# UNITED STATES PATENT AND TRADEMARK OFFICE

APPLICATION NO.	FILING DATE	FIRST NAMED INVENTOR	ATTORNEY DOCKET NO.	CONFIRMATION NO.
10/527,251	03/09/2005	Jean Taylor	31132.339	2831

<b>Office Action Summary</b>	<b>Application No.</b> 10/527,251	<b>Applicant(s)</b> TAYLOR, JEAN	
	<b>Examiner</b> Nicholas Woodall	<b>Art Unit</b> 3733

Figure 1

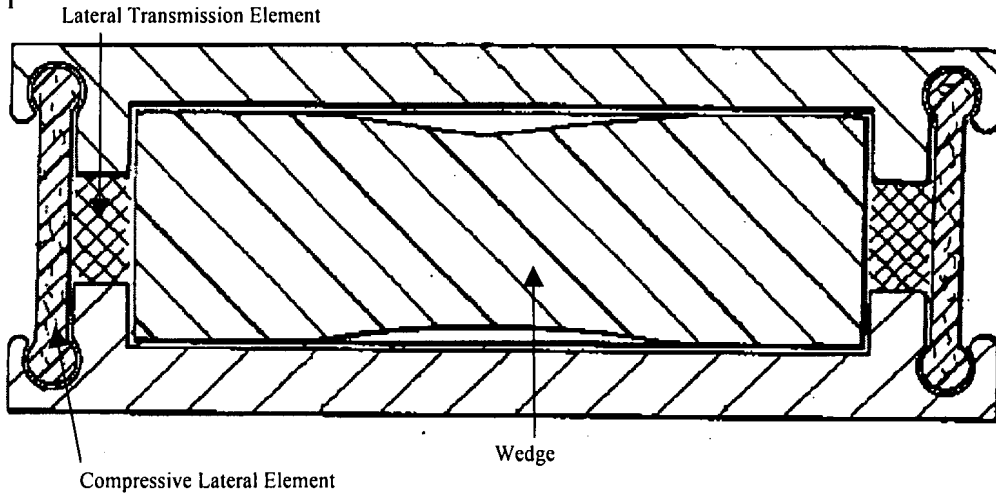
6. Claims 14-18 are rejected under 35 U.S.C. 102(e) as being anticipated by Eberlein (U.S. Publication 2003/0045940).

Regarding claim 14, Eberlein discloses a device that is capable of being placed between and in contact with the spinous processes of two vertebrae comprising an elastically deformable wedge wherein the deformable zone is the entire wedge, two compressive lateral elements, and two lateral transmission elements (see Figure 1 below). The compressive lateral elements are disposed on either side of the wedge in a longitudinal direction and are capable of being deformed between releasing and compressive positions. The lateral transmission elements are disposed between the wedge and the compressive lateral elements and are capable of pressing against the wedge in the transverse direction. Regarding claim 15, Eberlein discloses a device wherein the wedge has a limit of compressibility in the transverse direction and is capable of reaching that limit at a predetermined tilted position. Regarding claim 16, Eberlein discloses a device wherein the compressive lateral elements have a limit of deformation in the transverse direction and is capable of reaching that limit at a predetermined tilted position. Regarding claim 17, Eberlein discloses a device wherein the compressive lateral elements are elastically deformable between the releasing and compressive positions. Regarding claim 18, Eberlein discloses a device wherein the compressive lateral elements are elastically deformable along an axis of the spine.

Figure 2

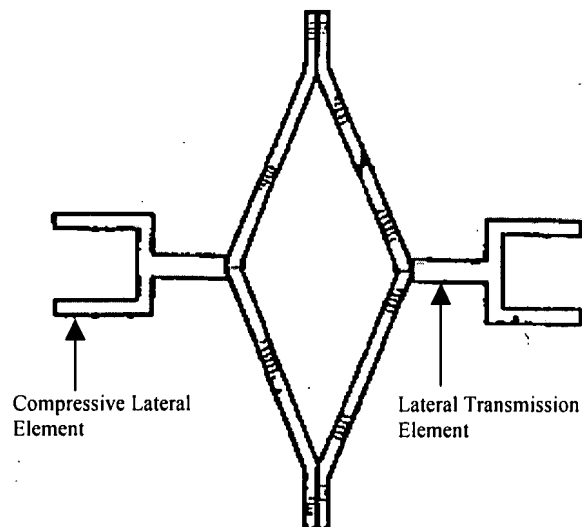
8. Claims 14-22, 24, 26, 27, and 34 are rejected as understood under 35 U.S.C. 103(a) as being unpatentable over Elberg (U.S. 6,440,169) in view of Samani (U.S. 5,645,599).

Regarding claim 14, Elberg discloses a device capable of being placed between and in contact with the spinous process of two vertebra comprising two compressive lateral elements and two lateral transmission elements (see Figure 2 below). The compressive lateral elements are disposed on either side of the wedge in a longitudinal direction wherein the compressive lateral elements are deformable between releasing positions and compressive positions. The two lateral transmission elements disposed

between the compressive lateral elements and the wedge and are capable of pressing against the wedge in the transverse direction. Regarding claims 17 and 18, Elberg discloses a device wherein the compressive lateral elements are elastically deformable between the releasing and compressive position and wherein the compressive lateral elements are elastically deformable generally along an axis of the spine (column 4, lines 52-53). Regarding claim 19, Elberg discloses a device wherein the compressive lateral elements are independent of one another and wherein each element is capable of being connected to a vertebra with one end and to another vertebra at the other end.

Figure 3

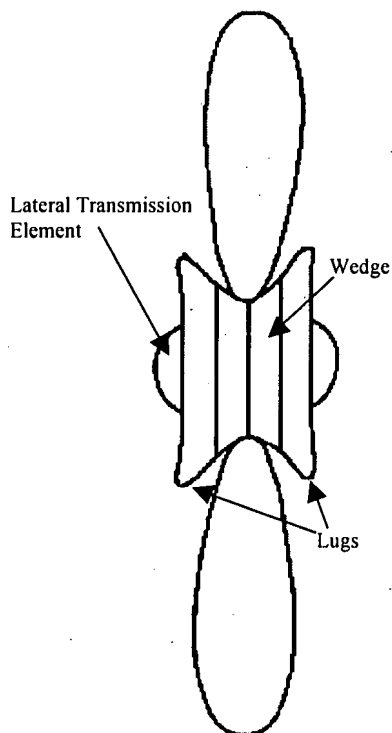
9. Claims 28, 30-33 are rejected under 35 U.S.C. 103(a) as being unpatentable over Zucherman (U.S. Patent 6,514,256) in view of Howland (U.S. Patent 5,496,318).

Regarding claim 28, Zucherman discloses a device comprising an elastically deformable interspinous wedge, wherein the zone of deformation is the entire wedge, capable of being inserted between the spinous processes of two vertebrae and first and second lateral transmission elements capable of pressing against the wedge in a transverse direction in response to forces applied to the first and second compressive lateral elements (see Figure 3 below). Regarding claim 30, Zucherman discloses a device wherein the first and second lateral transmission elements are bosses.

Regarding claim 31, Zucherman discloses a device wherein the bosses are integral with the wedge. Regarding claim 32, Zucherman discloses a device wherein the wedge includes recesses capable of receiving the bosses. Regarding claim 33, Zucherman discloses a device wherein the wedge comprises two curved recesses bound by two

lugs capable of broadly enveloping the spinous processes. Zucherman fails to disclose the device further comprising a circular strap capable of being placed around at least two spinous processes and the wedge. Howland teaches a device comprising a strap capable of being placed around at least two spinous processes and a wedge in order to hold the device in place (column 4 lines 58-67). It would have been obvious to one having ordinary skill in the art at the time the invention was made to manufacture the device of Zucherman further comprising a strap capable of being placed around at least two spinous processes and a wedge in view of Howland in order to hold the device in place.
